Queensland Competition Authority

QR Network's 2009 Access Undertaking

Assessment of Western System Asset Valuation

November 2009

Figure 1 - Fuel cost trends

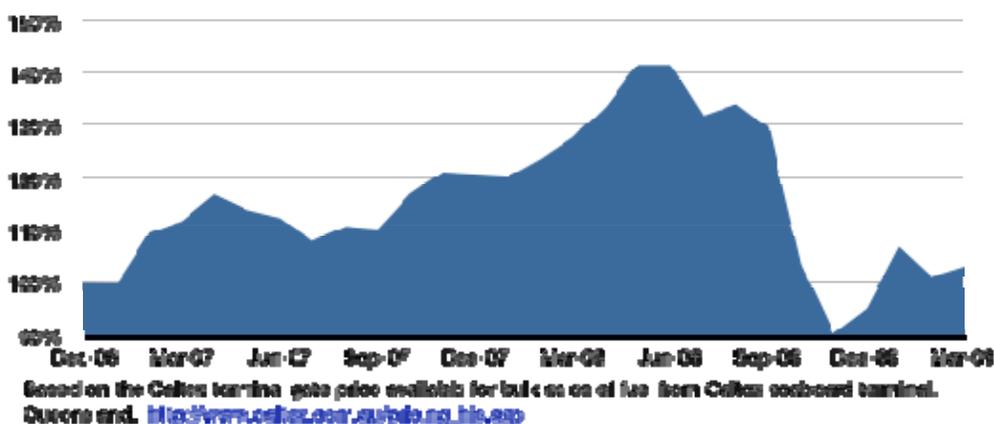
The fuel costs, as shown in Figure 1, based on the Caltex terminal gate prices, were approximately 40% lower in March 2009 than as at June 2008. Using the March 2009 value would reduce the maintenance costs by 1.7% or approximately \$1.0 million over the UT3 period.

Figure 2 - Maintenance costs over time (using 2001/02 as the base for comparison purposes)

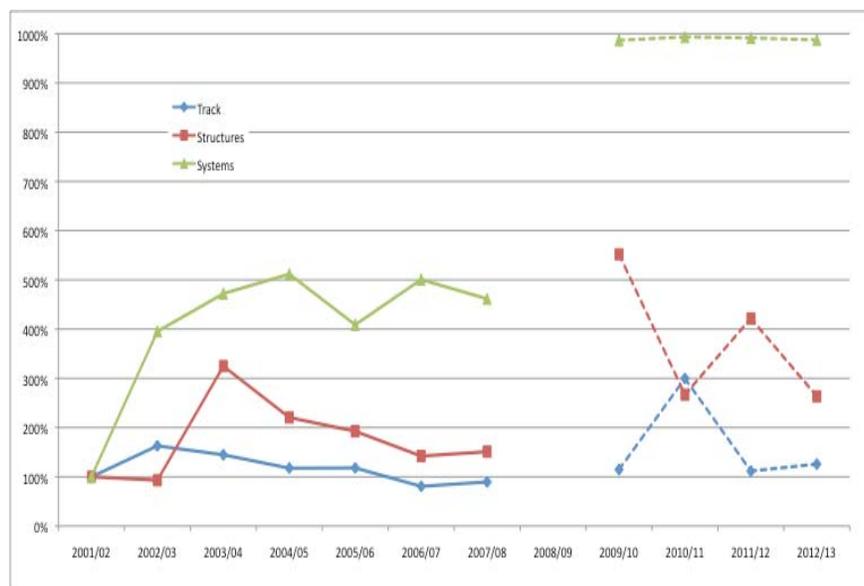
QRN have confirmed the maintenance costs for the Western System since 2001. These are as shown in Figure 2 below. For the purposes of this review a base date of 2001 has been used for comparison purposes.

- the track component of the estimated incremental maintenance costs appears reasonable and consistent with immediate past practices for maintaining the appropriate standard of the mainline; and
- the other major components of the maintenance costs, structures and systems appear high and there was no explanation provided as to why the forecast expenditure was not in line with the historical expenditure trends since 2001. If the maintenance expenditure for structures and systems was forecast to be in line with the longer term trend then the claimed expenditure would be reduced by 11% of the total claimed amount.
